KANSAS GAS AND ELECTRIC COMPANY

July 20, 1984

Subj: Technical Specifications

TECHNICAL SPECIFICATION CHANGES

FIGURE 3.2-3

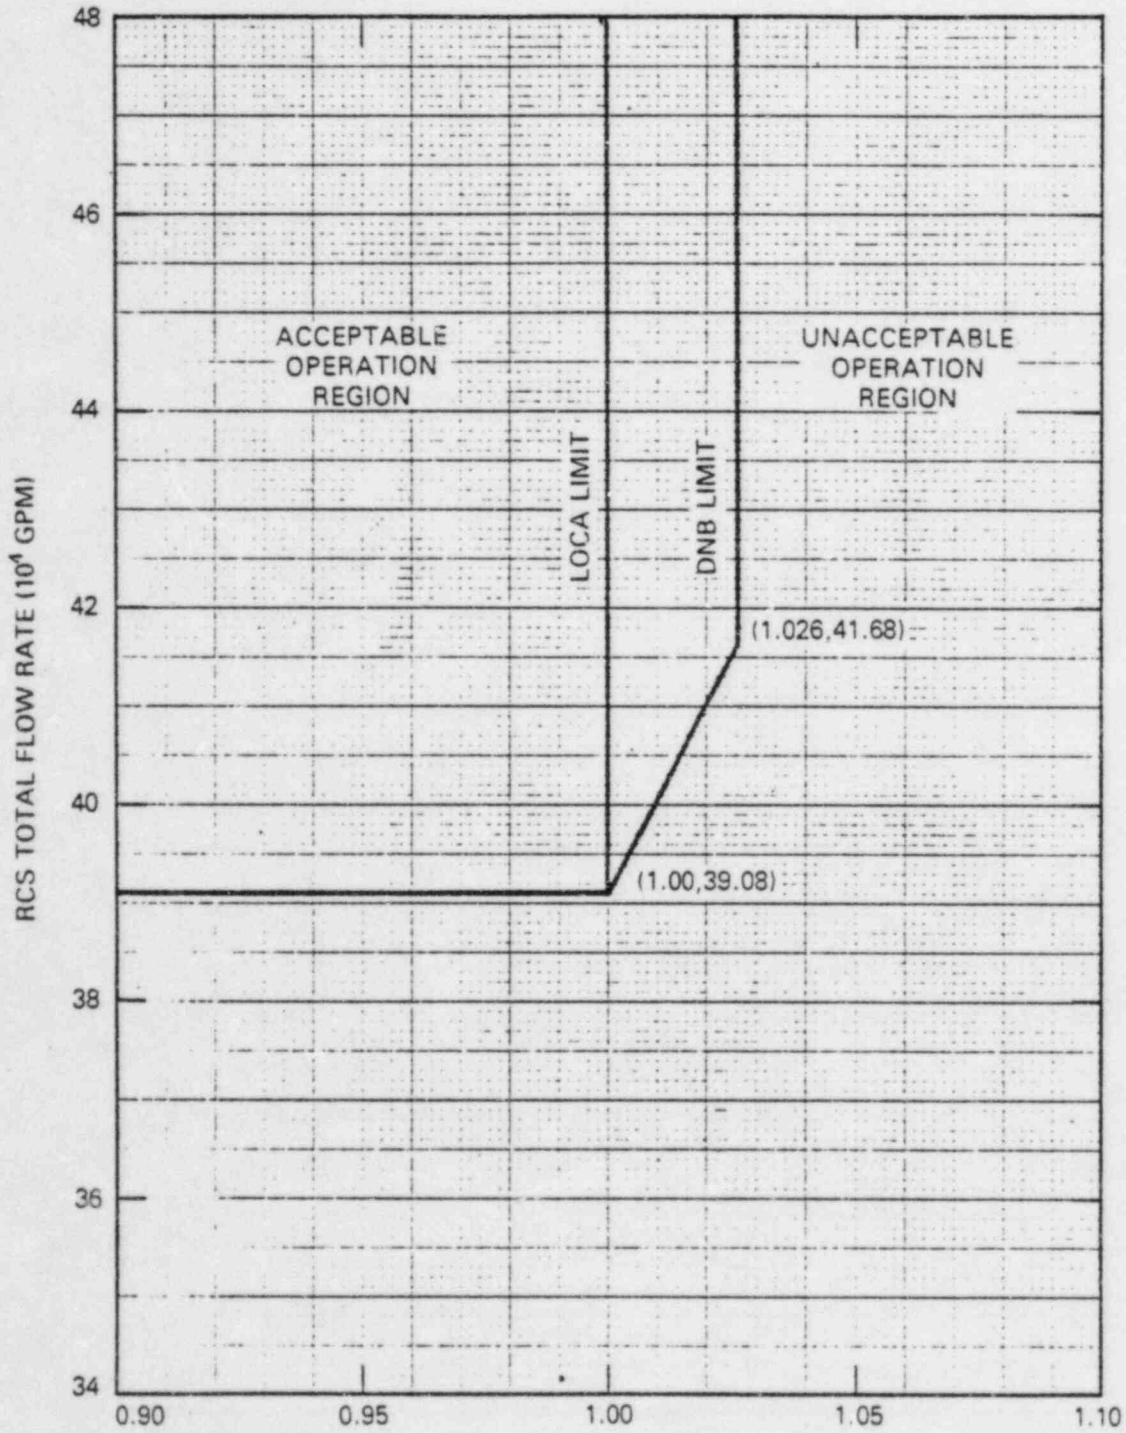
Page	Section	Reason for Change
3/4 2-9	Figure 3.2-3	Make Wolf Creek specific.
3/4 2-10	4.2.3.5	Consistent with Callaway T.S. Includes Wolf Creek specific instrument.
3/4 2-11	3.2.4	Consistent with Callaway T.S.
3/4 2-15	Table 3.2-1	Consistent with Callaway T.S.
3/4 3-2	Table 3.3-1 (6b & 6c)	Consistent with Callaway T.S.
3/4 3-3	Table 3.3-1 (12a & 12b)	Consistent with Callaway T.S.
3/4 3-4	Table 3.3-1 (19)	Consistent with Callaway T.S.
3/4 3-5	Table 3.3-1, Table Notations	Consistent with Callaway T.S.
3/4 3-6	Table 3.3-1 (Action 5)	Consistent with Callaway T.S.
3/4 3-6	Table 3.3-5 (Action 5 - deletion of Boron Dilution Techni- cal Specification)	Justification provided by KMLNRC 84-034, dated 3/16/84
3/4 3-7	Table 3.3-2 (1)	Consistent with Callaway T.S.
3/4 3-8	Table 3.3-2 (Heading & Item 12)	Consistent with Callaway T.S.
3/4 3-9	Table 4.3-1 (item 6 - deletion of note (12))	Justification provided by KMLNRC 84-034, dated 3/16/84

FIGURE 3.4-2
REACTOR COOLANT SYSTEM HEATUP LIMITATIONS
APPLICABLE UP TO 16 EPY

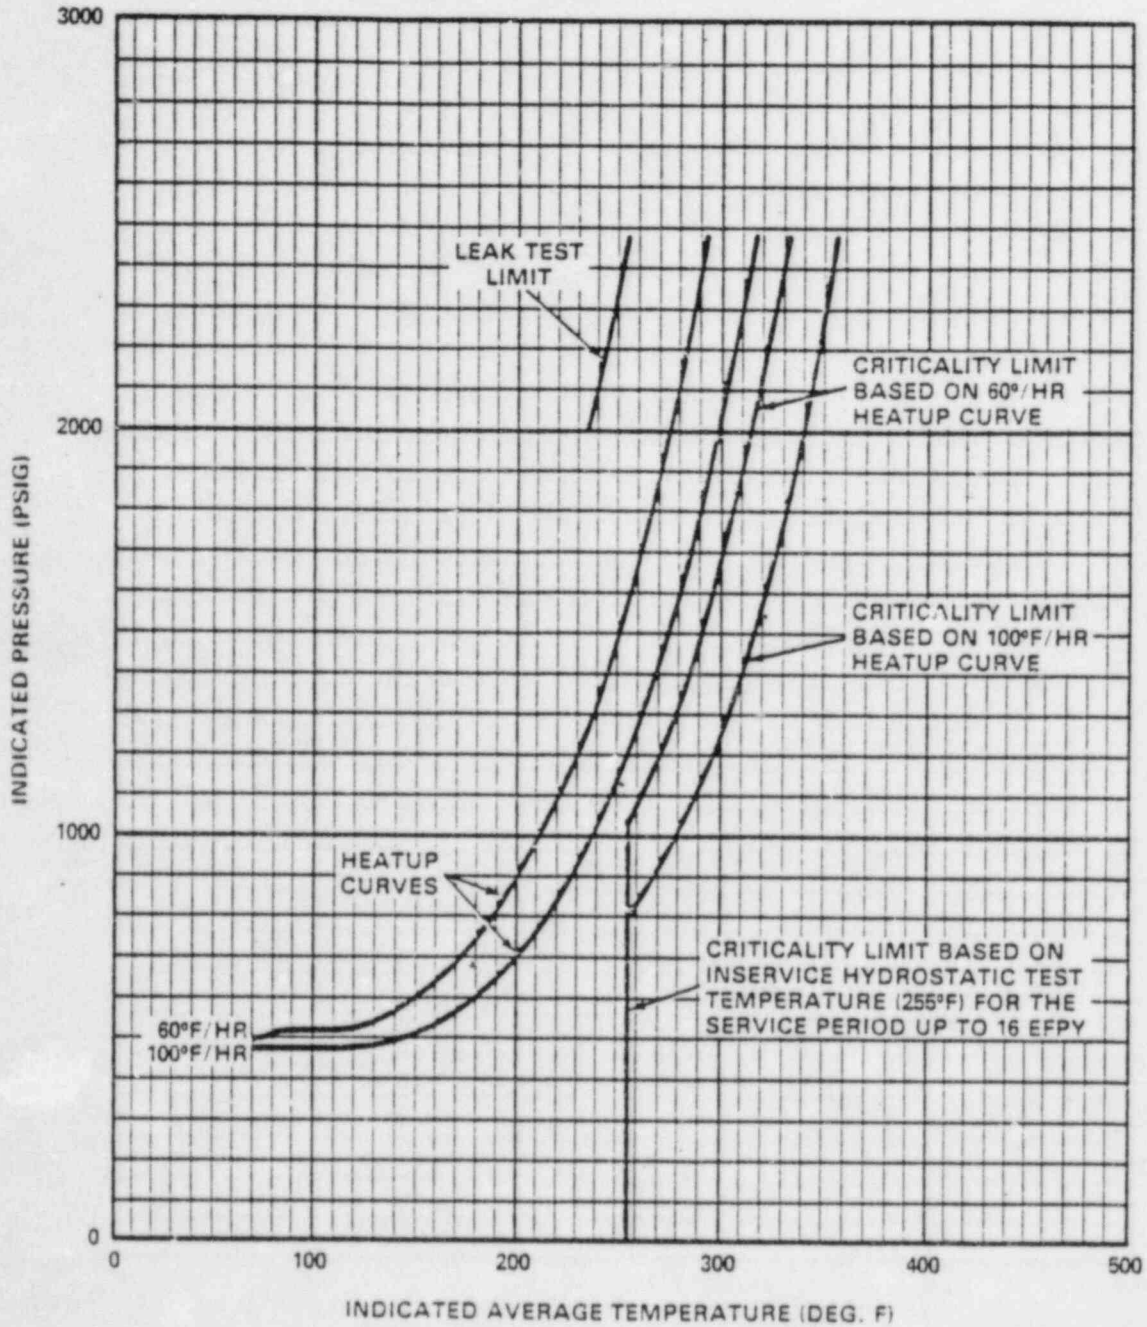
Page	Section	Reason for Change
3/4 4-29	4.4.9.1.2	Consistent with Callaway T.S.
3/4 4-30	Figure 3.4-2	Consistent with Callaway T.S.
3/4 4-31	Figure 3.4-3	Consistent with Callaway T.S. with Wolf Creek specific notch in curve.
3/4 4-32	Table 4.4-5	Consistent with Wolf Creek analysis
3/4 4-34	3.4.9.3	Consistent with Callaway T.S. and justification provided
3/4 4-34	3.4.9.3 (a, b, & c and Actions a, b, & c)	Consistent with Callaway T.S. and justification provided.
3/4 4-35	4.4.9.3.2 & 4.4.9.3.3	Consistent with Callaway T.S.
3/4 4-36	Figure 3.4-4	Consistent with Callaway T.S.
3/4 5-1	3.5.1.a and Action b	Consistent with Callaway T.S.
3/4 5-2	4.5.1.1 (b,c,&d)	Consistent with Callaway T.S.
3/4 5-3	3.5.2 (* note)	Consistent with Callaway T.S.
3/4 5-5	4.5.2.e.1)	Consistent with Callaway T.S.
3/4 5-6	4.5.2.h.3) & 4.5.2.i	Consistent with Callaway T.S.
3/4 5-7	3/4.5.3 (Heading)	Consistent with Callaway T.S.
3/4 5-7	3.5.3.d and 3.5.3 (Action a & c)	Consistent with Callaway T.S.

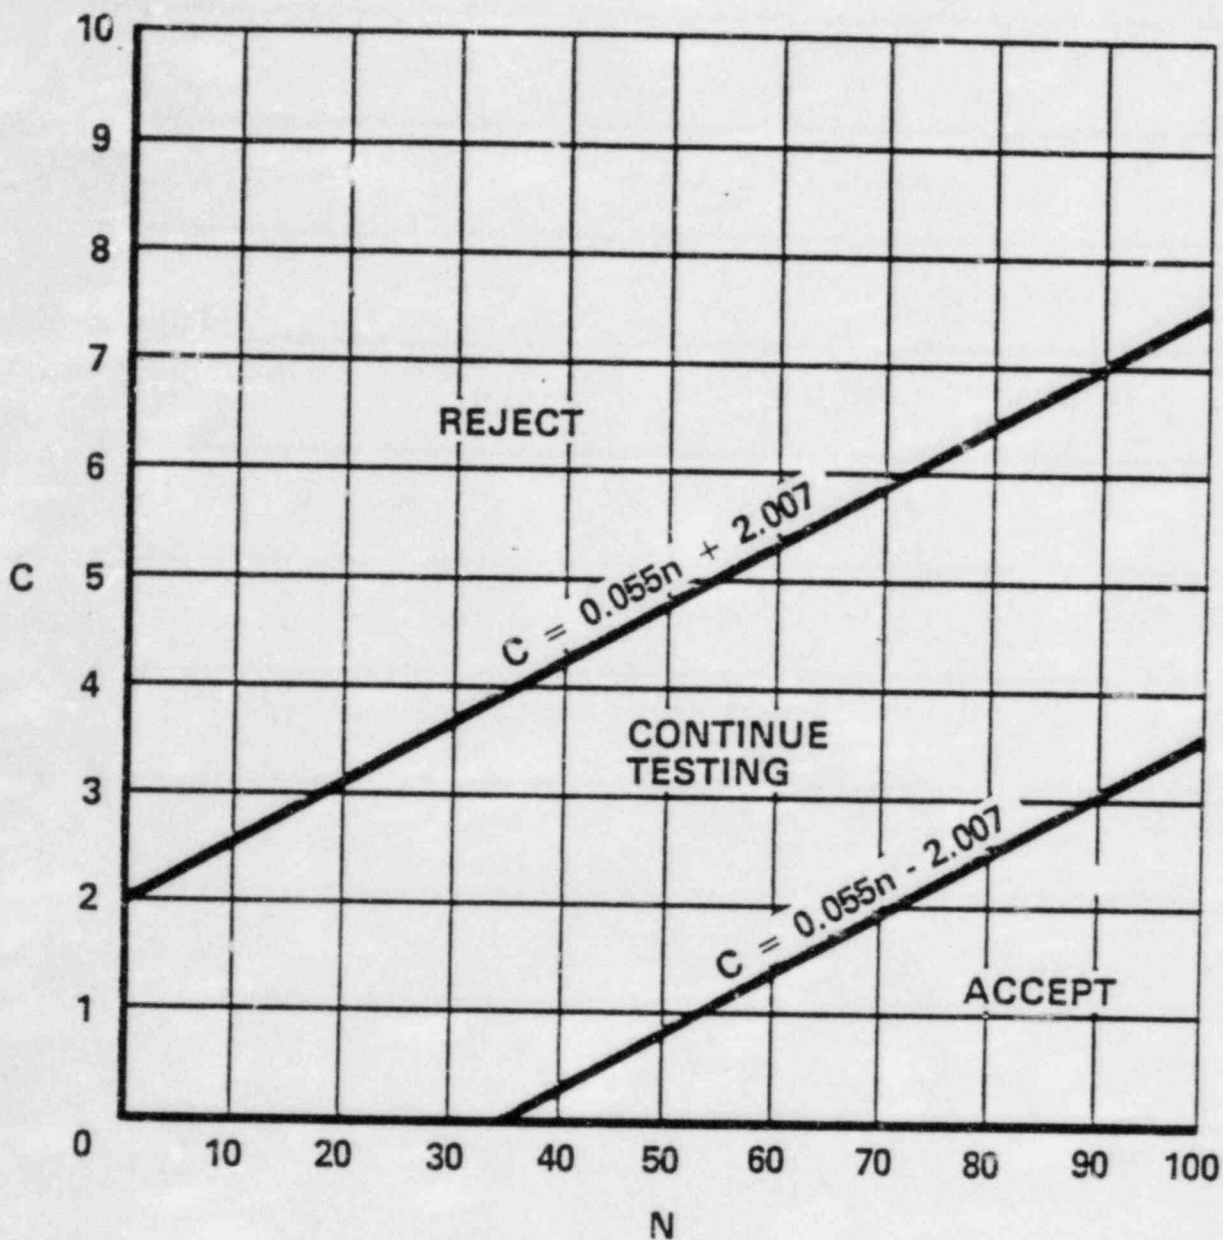
Insert > Figure 4.7-1 was developed using "Wald's Sequential Probability Ratio Plan" as described in "Quality Control and Industrial Statistics" by Acheson J. Duncan.

FIGURE 5.1-2
 LOW POPULATION ZONE

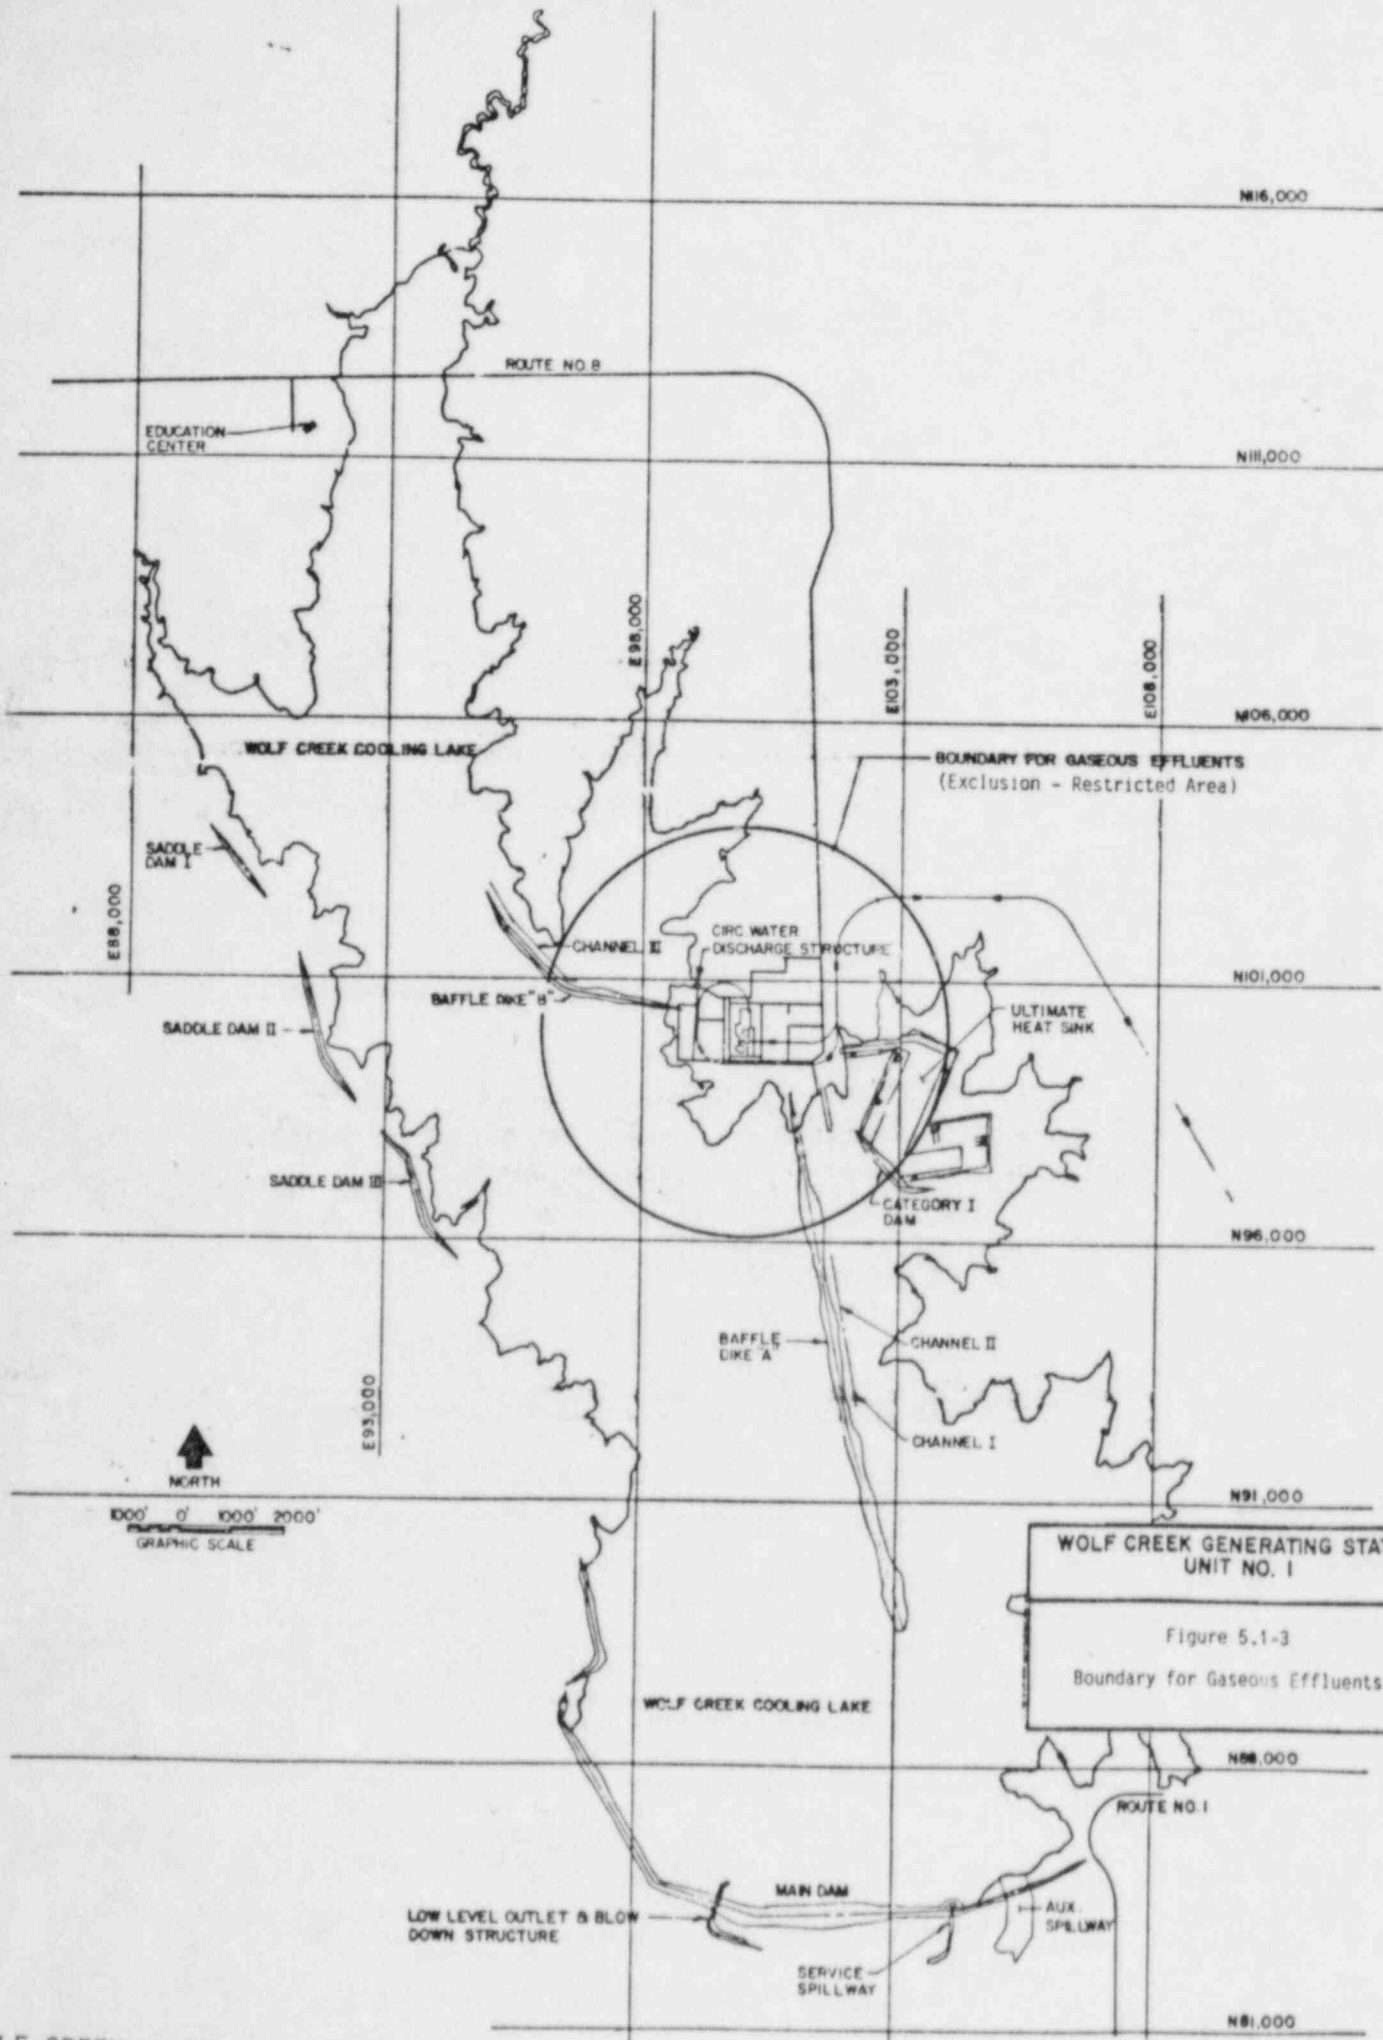
5-3	Figure 5.1-2	Wolf Creek specific justification provided
5-4	Figure 5.1-3	Wolf Creek specific justification provided
5-5	Figure 5.1-4	Wolf Creek specific justification provided

This figure was revised for clarity.

Figure 5.1-3
Boundary for Gaseous Effluents

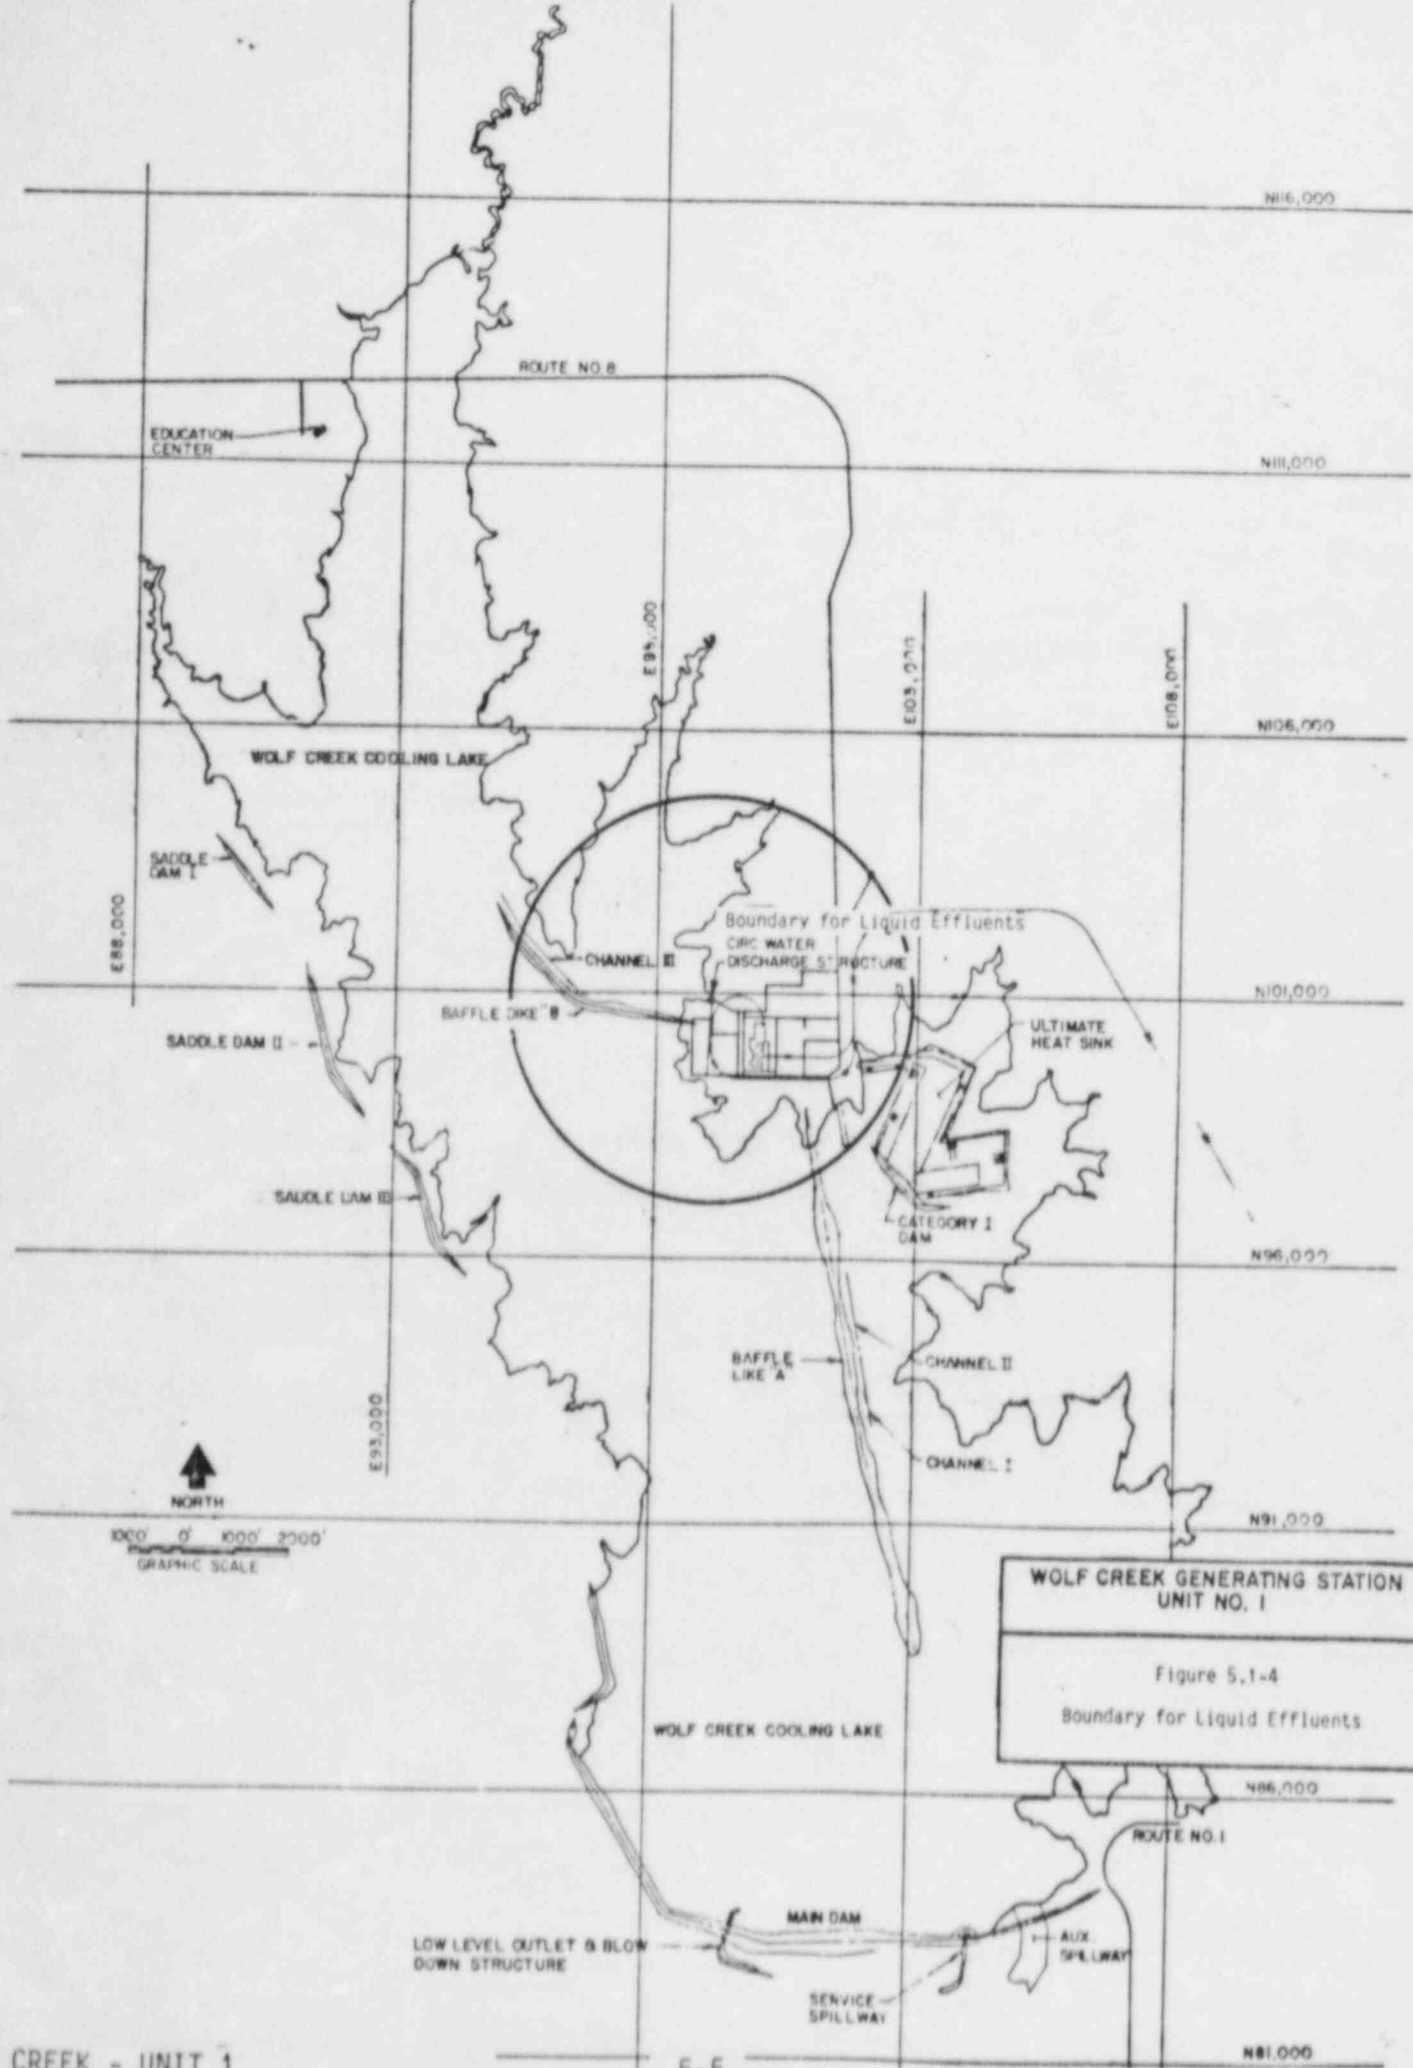
The figure was revised for clarity.
